NIBLEY CITY COUNCIL MEETING AGENDA

Agenda Item #6

Description	Discussion & Consideration – Preliminary Plat for Ridgeline Park East, containing 333 Residential Units, Located at Approximately 250 W 3200 S.
Presenter	Levi Roberts, City Planner
Recommendation	Move to approve the Preliminary Plat for Ridgeline Park East with the conditions listed below
Reviewed By	Mayor, City Manager, City Planner, City Engineer

***RIDGELINE PARK EAST
SUBDIVISION
PRELIMINARY PLAT***
LOCATED IN THE NW1/4 OF SECTION 21, T11N, R1E, SLB&M
NIBLEY, UTAH

**STORMWATER
PLAN**

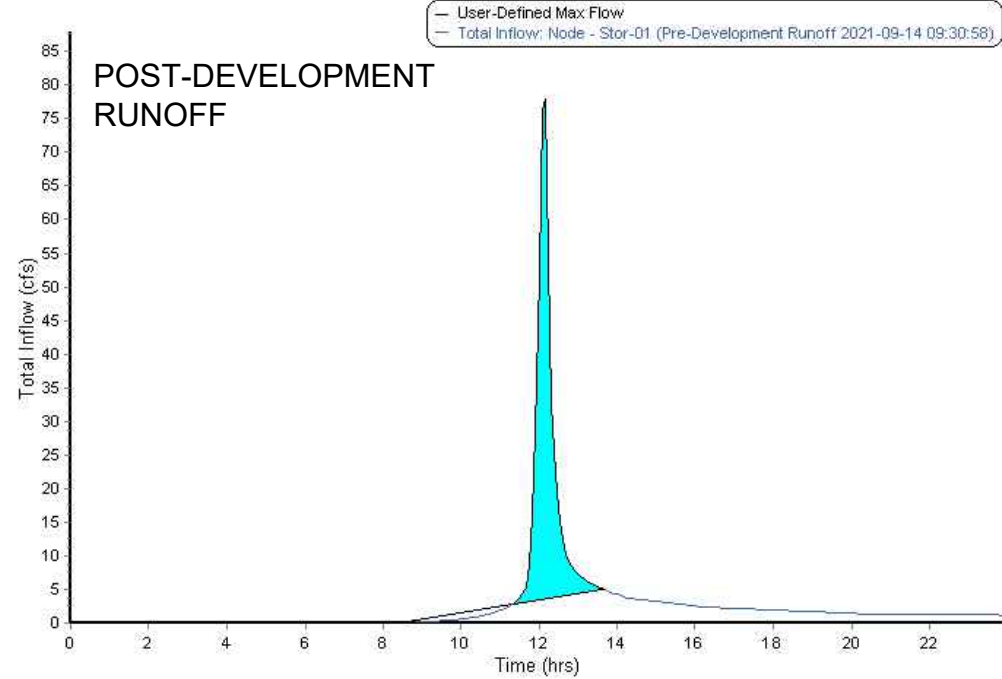
OUTSTANDING COMMENT	STATUS	EFFECTS TO THE PRELIMINARY PLAT
The final stamped drainage report to be submitted with construction plans shall include a narrative documenting offsite stormwater impacts to the project, provide specific details on how the storm tech system will function, and other information that is unique to this project.	1) The City needs the engineer to confirm that any stormwater impacting the project from adjacent properties is being managed. This condition may exist on the north and at the commercial property if not included in the preliminary plat. 2) Visionary has stated there isn't a concern but have not included any language in the preliminary plat.	1) Additional drainage features (channels, basins, etc) may be required to manage stormwater from offsite areas.
It is difficult to understand how the use of stormtech chambers will be possible given the shallow depth of groundwater. This will need to be clearly explained in the stormwater study and may result in the requirement to construct stormwater basins to replace the chambers.	1) Stormtech chambers hold stormwater below a parking lot. They have never been used in Nibley because of high groundwater. It is unclear that the design will be able to meet City Standards. 2) The engineer is not ready to provide sufficient detail to confirm that the chambers can meet City standards.	1) If the chambers do not meet City standards, new basins may have to be created and has the potential to change the configuration of the preliminary plat layout.

SEWER		
After further review with the additional sewer elevation information provided, the option to eliminate the lift station & force main and to extend sewer west across the park area is the City's preferred option. Further evaluation of this option will be reviewed with the detailed information provided with Construction Plans.	1) After receiving requested sewer design information with the 3rd submittal, Staff was able to determine that the proposed sewer lift station will likely not be needed as sewer can flow to an existing manhole through the park area. 2) The preliminary plat still shows a lift station site. 3) Visionary is supportive of moving in this direction.	1) This would remove the sewer lift station site from the preliminary plat
Is there enough slope in the sewer system to construct the proposed bypass around the commercial area? It would seem as though the southwestern most condos could more easily sewer to the east rather than south to west to north to east.	1) The City is concerned about sufficient slope being available to design the sewer system as proposed. 2) The City is also concerned about the proposed sewer layout in the Condo area. 3) Visionary believes there is sufficient slope to build the bypass and is willing to look at changing the sewer lines in the condo area.	1) If the slope isn't sufficient, they would need to reconfigure the proposed sewer system. 2) The City will likely change the sewer system configuration in the Condo area to sewer in a better manner.
